Herefordshire Local Plan

Hereford Area Plan

Housing and Employment Site Options Consultation

Technical Site Assessments - Central Hereford

Thr30

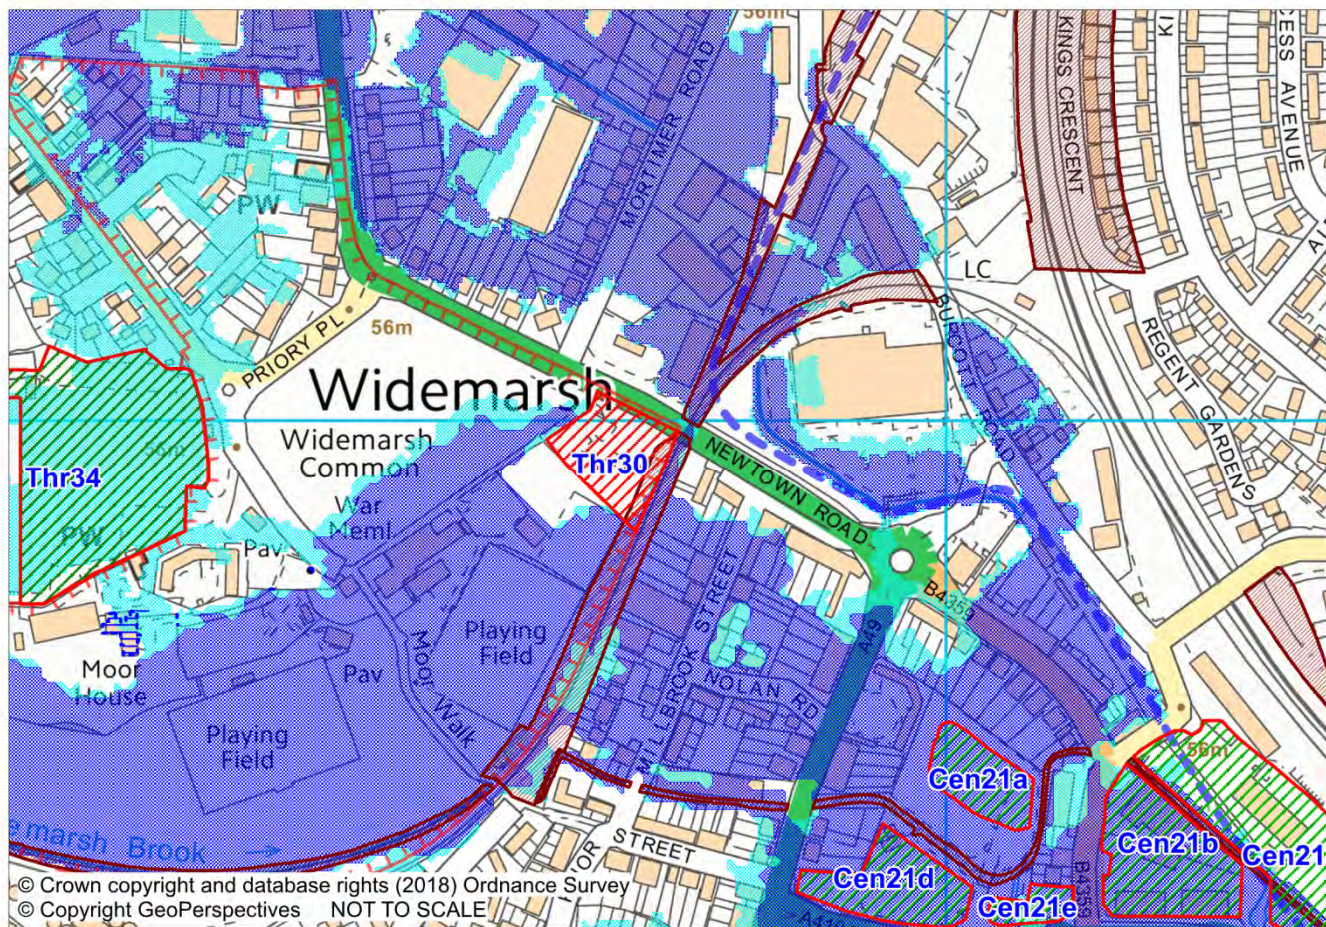
HC Highways comments
Public Transport accessibility comments
<i>Are standards for access to local services likely to be achievable?</i> Yes. Close to cycleways (Great Western Way passes site), pedestrian routes, bus services, school and employment areas.
Access comments
Severe access problems. Highways England will not allow access onto A49 Newtown road. Only alternative access route is perimeter road along the edge of Widemarsh Common. If no more dwellings were proposed than the number that could be served off a private drive (5 dwellings), then the common perimeter road, with the addition of a couple of passing bays, would be acceptable to serve the development.
Local network comments
<i>Any capacity concerns on this section of the network?</i> Not that would be directly impacted to any degree by a further 5 dwellings, but the cumulative impact of this and other sites needs to be considered.
Site dependence on Hereford Transport Package

Not directly. An overall assessment of the acceptability with regard to highway network capacity will need to be carried out (once all sites are reviewed and shortlisted) to assess the cumulative impact and at which stage of the HTP those developments can be brought forward.
Mitigation measures
Addition of laybys to common perimeter road.
Highway site support
Yes.

HC Conservation comments
Built conservation
The Widemarsh Conservation Area is a key heritage constraint for the site. Any development should protect or enhance the character and appearance of the Conservation Area.
Archaeology
Suitable. This is a comparatively small site that has been prior disturbed. There are no archaeological records of substance relating to it.
Biodiversity/Ecology
HRA – River Wye SAC/SSSI All foul water should be managed through connection to main sewer network. Confirmation that this is possible and also acceptable to Welsh Water is necessary. No direct discharge of any foul water outfall from any onsite treatment

A recent Ecology report concludes that there is a high potential for use by reptiles (in particular slow worms) of the site. Suitable provision for relocation of such species would need to be identified.

Severe access issues for this site. Highways England will not agree the use of the existing access onto the A49. Although the site is not within a flood zone 2 or above it is adjacent. There are also areas identified as being vulnerable to surface water flooding adjacent to the site. The management of surface water is an increasingly important issue and the LPA would need to be satisfied that the site could be satisfactorily drained without increasing the risk of flooding to the site, vicinity or downstream of the site. A drainage strategy would be necessary to determine the site's risk.

The site has severe access problems and Highways England will not agree the use of the existing access onto the A49. Through recent considerations, it has been agreed that as the road serving the site cannot be upgraded to a standard that can facilitate two way traffic (to an adopted standard) the LPA would only accept the number of dwellings that could be served off a private drive (5) including two passing bays on the un-adopted private road. As this affects the Village Green there is separate legislation that would need to be pursued, outside of the planning process and there is no certainty of this at this stage.
